REMARKS

The above Amendments and these Remarks are in reply to the Office Action mailed 03 November 2006. No fee is due for the addition of any new claims.

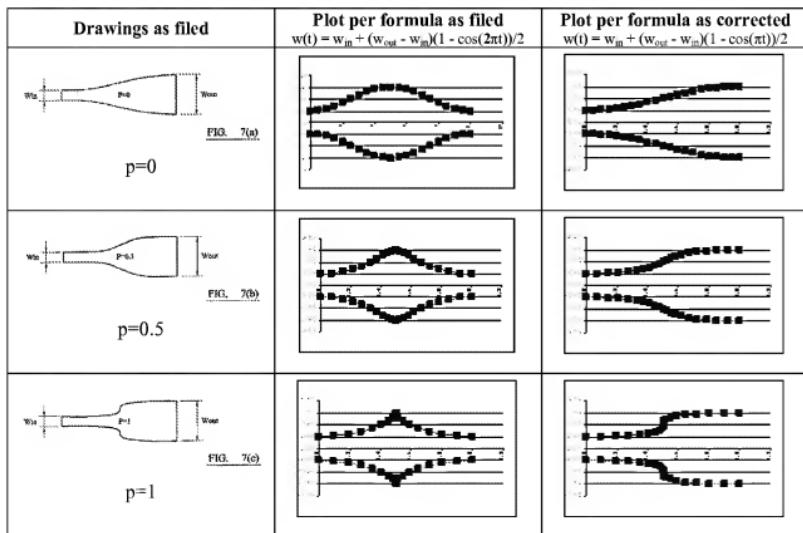
The Examiner objected to the amendment made by applicants to a formula on page 5 of the specification as introducing new matter. The Examiner states that the added material is not supported by the original disclosure, because "the reason for the amendment was not clear, and the change in the formula may significantly impact the design of the stated invention."

The shapes in Figs. 7(a)-7(c) (collectively "Fig. 7") illustrate the waveguide shapes that the correct formula would produce, for three values of the parameter p ($p=0$, $p=0.5$ and $p=1$). Set forth below is a table showing the drawing as filed in column 1, a new plot of the formula as filed in column 2, and a new plot of the formula as corrected in column 3:

It is apparent immediately that the formula as filed does not match the drawings as filed, and the formula as corrected does.

Moreover, it would be apparent to a person of ordinary skill from looking at the plots in column 2, exactly what needs to be corrected in the formula as filed in order to produce plots matching those of the drawings as filed. In particular, the person would note from the drawings in column 2 that for all three values of p , the width of the waveguide starts at w_{in} and grows to the output width w_{out} halfway along and then goes back again to the input width w_{in} . Thus, the width variation as defined by the formula as originally filed varies two times as quickly as what is shown in the drawings as filed. Since the parameter responsible for the speed of the width variations (i.e. the longitudinal positions, left-to-right, at which the variations occur) is the argument of the cosine term in the formula for $w(t)$, it would be evident to the person that this argument should be half what is shown in the formula as filed. With this reasoning the person of ordinary skill would come up with the above "formula as corrected", and would plot it and confirm that the resulting plots match the drawings as filed exactly, for all three example values of p .

Applicant responds that no new matter is added, since a person of ordinary skill would have no problem in recognizing the error in the original equation, and in knowing how to correct it.

Accordingly, it is submitted that not only would a person of ordinary skill know from the originally filed drawings that the formula as filed is incorrect, but also would know exactly what needs to be corrected in the formula as filed in order to produce matching plots. And the person would come up with the "formula as corrected" as set forth above.
